Warranty Field Campaign

Campaign Number: c2577	Revision: F	Released Date: 18-Dec-2025
BES CM2450 EV101B Prox 2 Connectivity Module Update Campaign		Expiration Date (U.S. and Canada): 31-Jul-2026
		Expiration Date (International): 31-Jul-2026

Description

Rover Telematics – Saucon Module – Prox2 Production changes

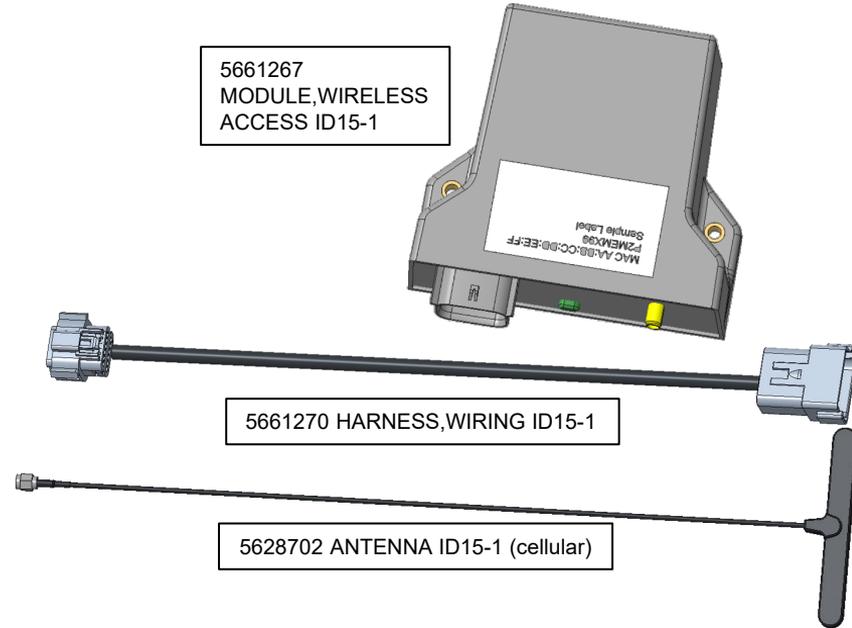
Prox1 5615688 ID21 Manufacturing Assy

Prox2 Components

Rover Telematics – Saucon Module – Prox2 UPFIT

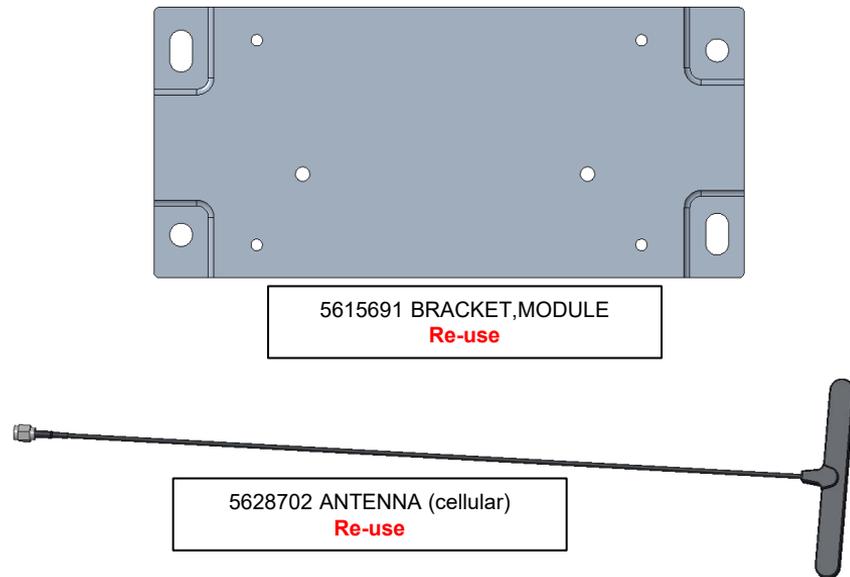
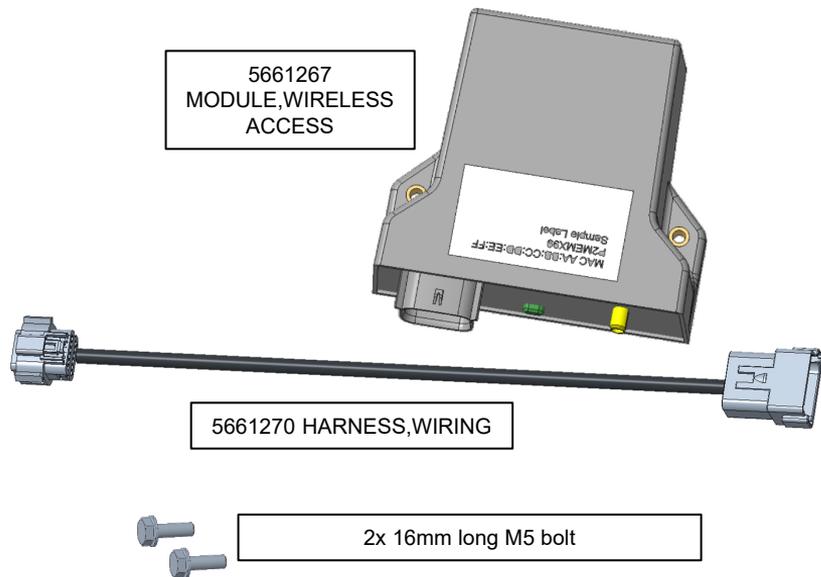
Required parts for Prox1 to Prox2 upfit:

Rover Telematics – Saucon Module – Prox2 UPFIT instructions

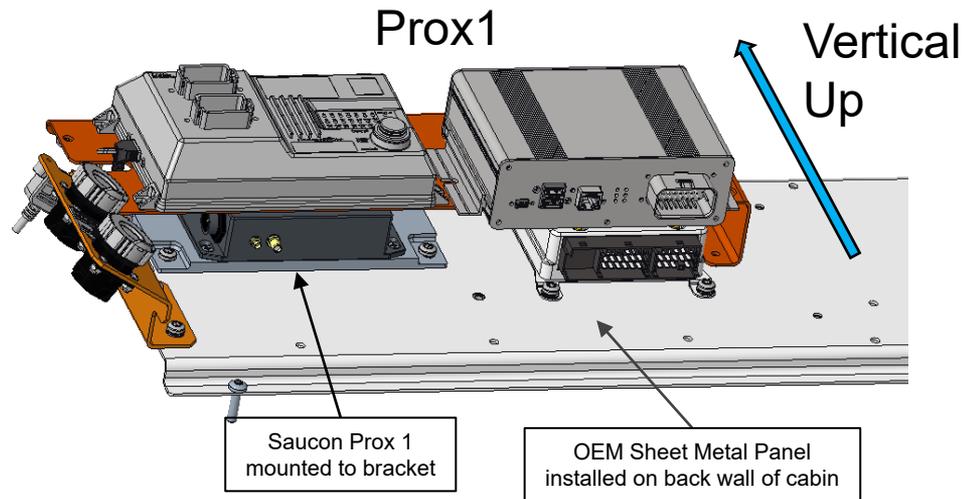
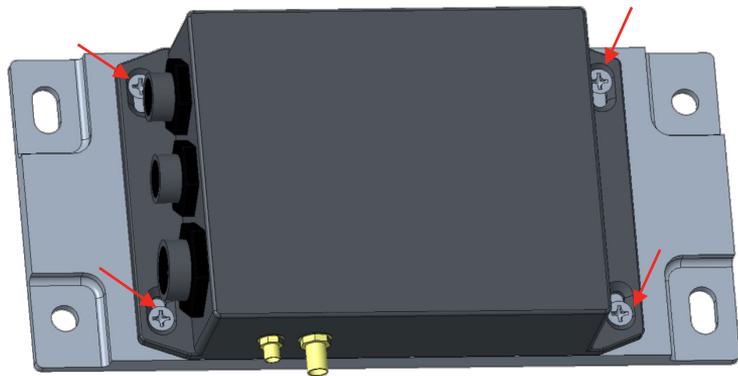
1. Disconnect cellular antenna, but leave installed (will reconnect and use)
2. Disconnect & remove jumper harness and GPS antenna.
3. Remove Prox1 module/bracket from OEM panel; save (4) OEM screws for re-use.
4. Remove 4 M4 screws attaching Prox1 to bracket

Rover Telematics – Saucon Module – Prox2 UPFIT instructions (cont.)

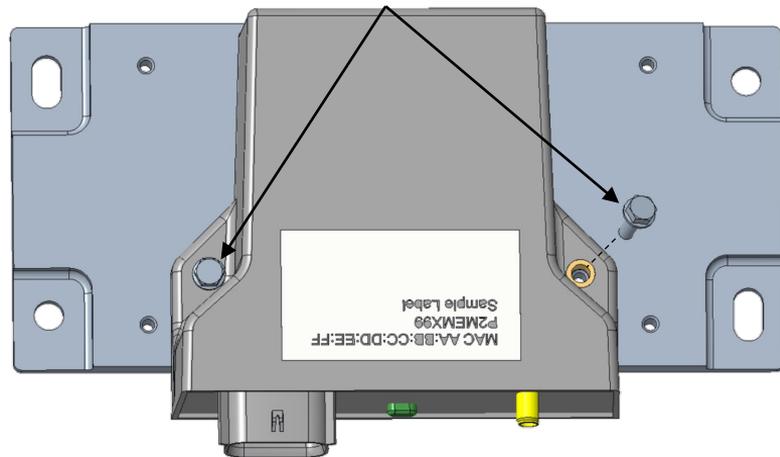
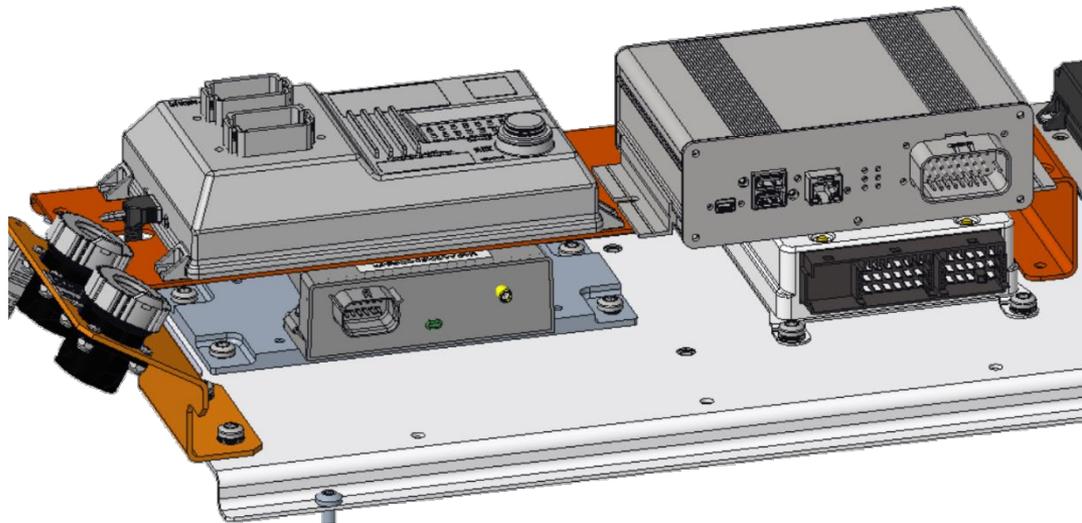
6. Attach Prox2 module bracket using existing 16mm long M5 bolts

1.8 Nm \pm 0.3 Nm

7. Install Prox2/bracket assembly to OEM panel re-using (2) OEM screws. Mount the top of the bracket to the bottom OEM panel holes to shift the bracket down
8. Re-connect cellular antenna.
9. Install new jumper harness.
